PUMP AND VALVE OPERABILITY  
SUMMARY FOR  
BYRON UNITS 1+2  
CAE/CBE

Subject Review of Seismic Report for Storage Battery & Battery  
Racks (1&2DC01EA,EB; 1&2DC02EA,EB)

Storage Batteries  
S&L Contract F/L 2819  
CECo P.O. Nos. 194757/194758  
Gould S.O. KE 5145, 5147, 5149, 5186

Legend

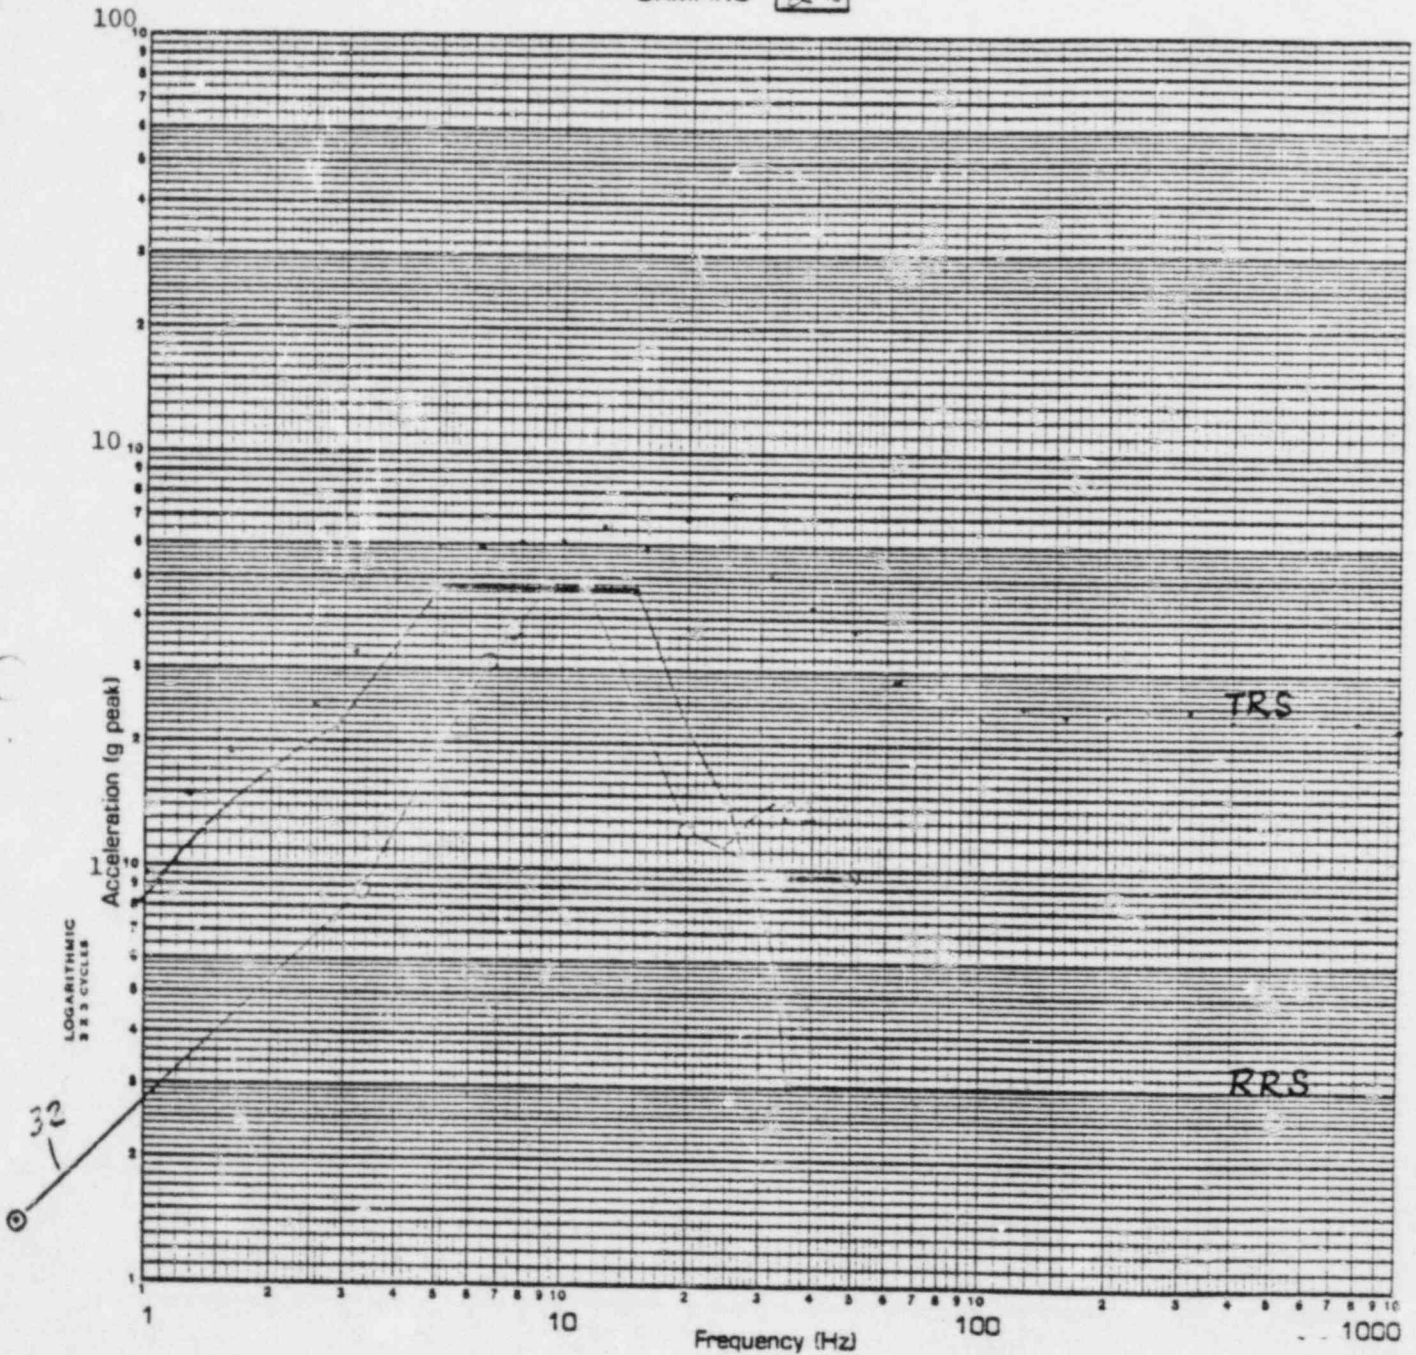
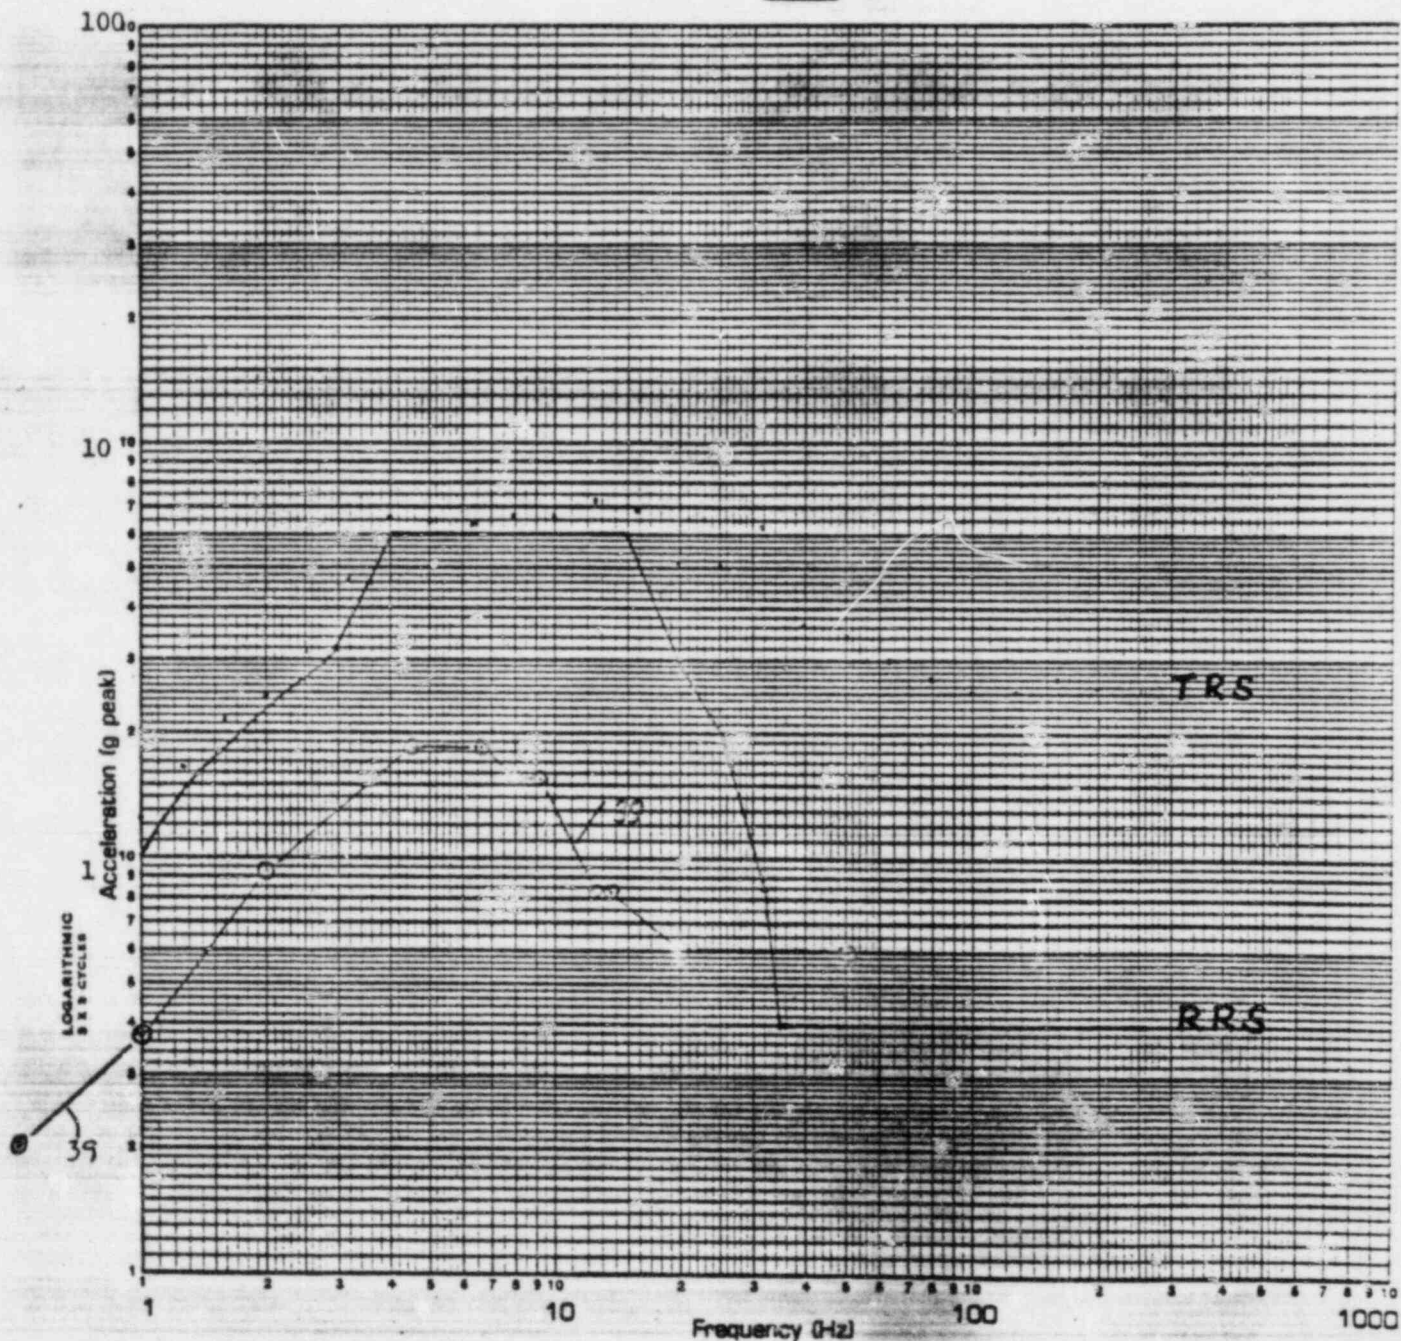
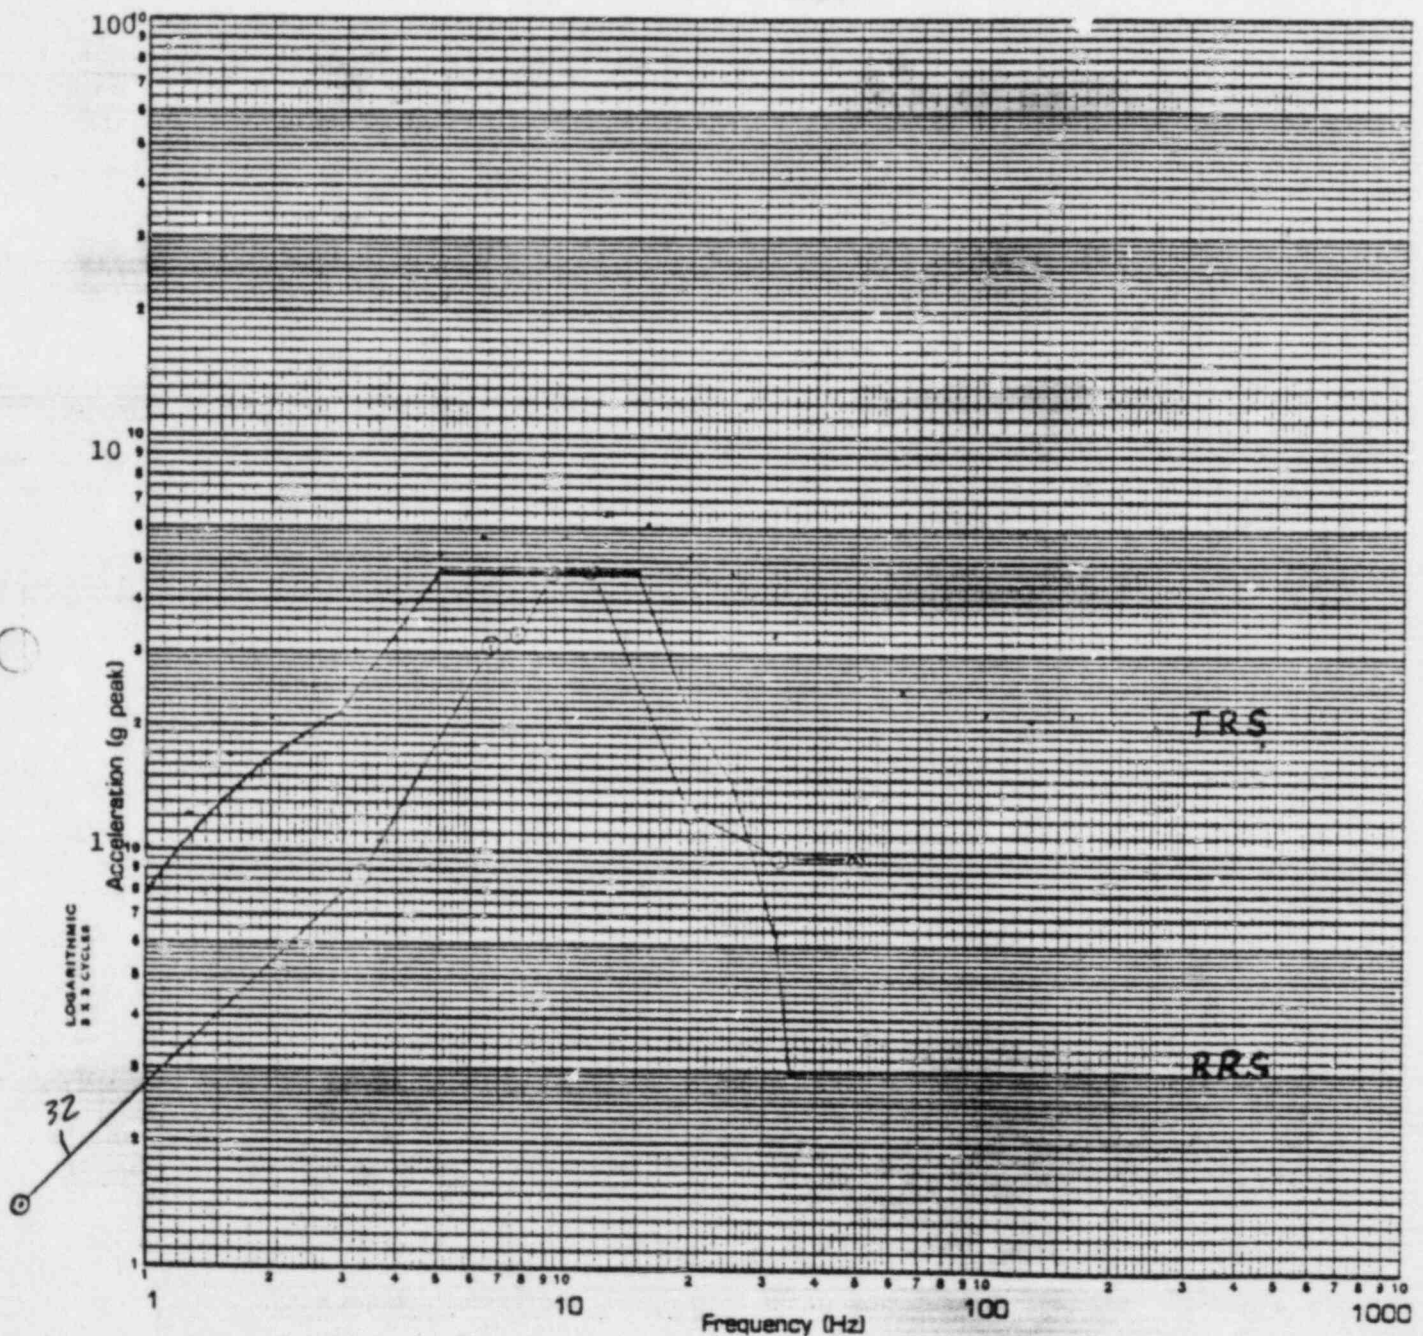
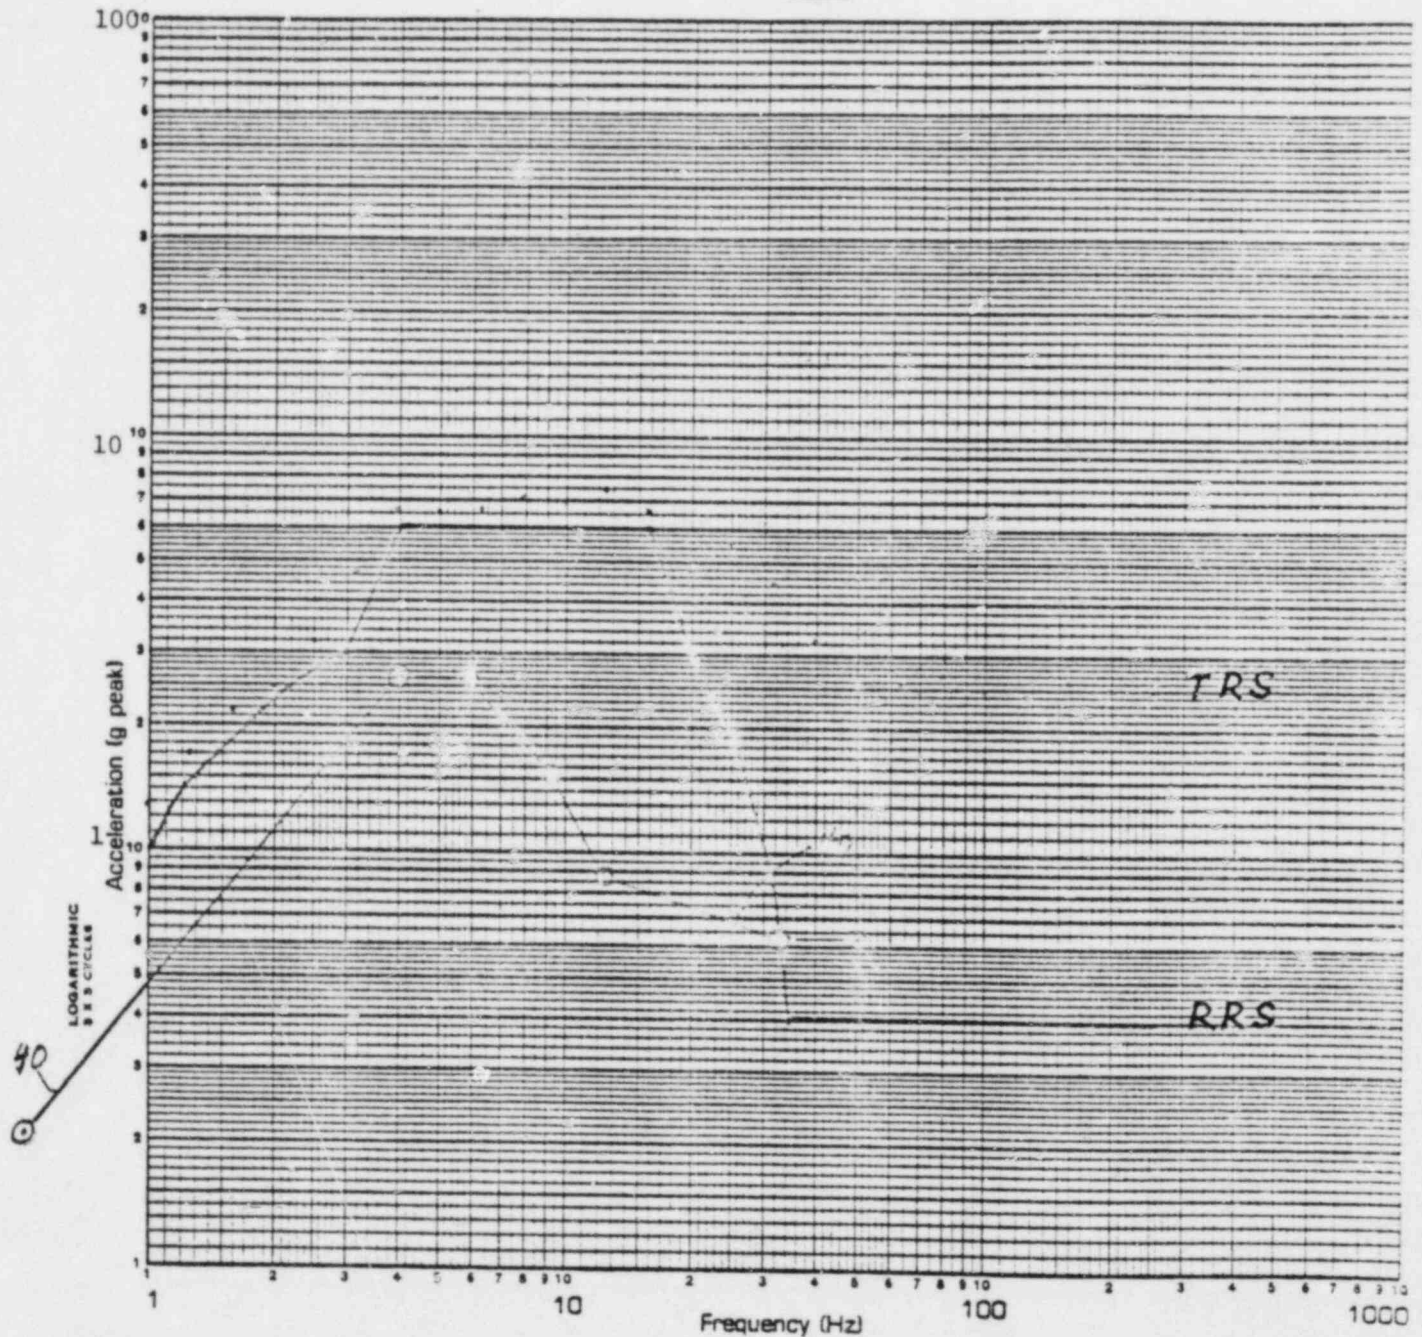
- c) Duration: 30 Secs.
- d) Does Test Response Spectra (TRS) envelop the Required Response Spectra (RRS)?
- ☒ Yes - Provide RRS and TRS as attachment
- ☐ No - Explain: \_\_\_\_\_
